B-701 (DH) - Box 6

| BECHTEL PROJECT NO.: 25409 | | MACTEC PROJECT NO.: 6468-07-1950 | | COUNTY: Miami-Dade | | GEOLOGIST: J. Liles | | | | | | | |
|------------------------------------|------------|--|-------|---|----------------|---------------------------------|----|----|----|-----------|-----------|---------------------------|---|
| SITE DESCRIPTION: Turkey Point COL | | DRILL MACHINE: CME-550 (Miller) | | DRILLER: R. White/ J. Dugger/ C. White | | GROUND WATER (ft) | | | | | | | |
| BORING NO.: B-702 | | DRILL METHOD: Mud Rotary/ Core | | SAMPLE METHODS: SPT/Core | | 0 HR. NA | | | | | | | |

B-B-701 (DH) - Box 15

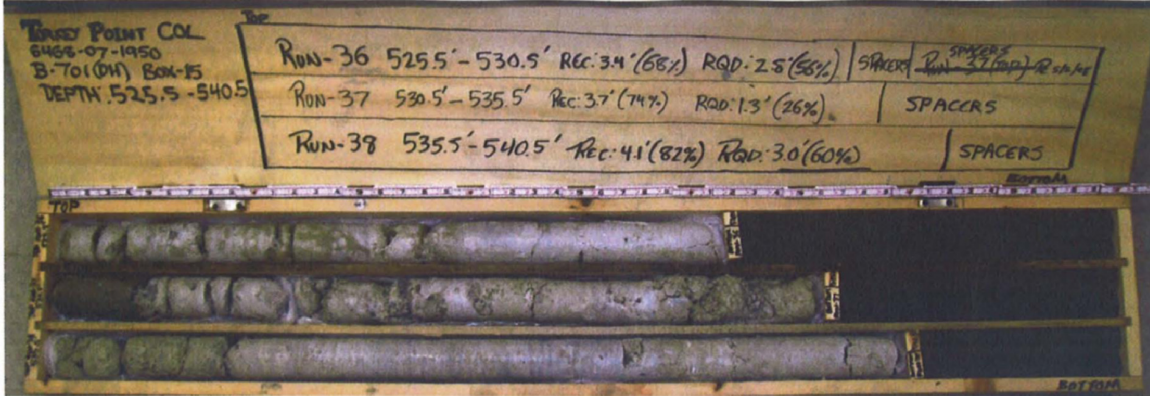
Corrections: Run 40, REC 3.7'(74%), RQD 1.6'(32%)
Run 41, REC 5.0'(100%), RQD 4.1'(8.2%)
JPH. 8-18-08

B-701 (DH) - Box 19

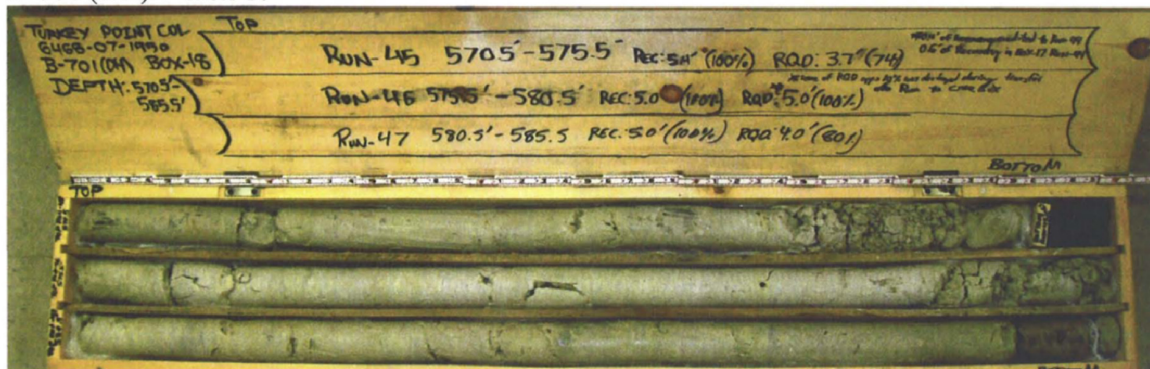
Corrections: Run 53, REC 2.0' (100%), RQD 1.6' (80%)
Run 54, REC 3.0' (100%), RQD 3.0' (100%) JPH, 8-18-08
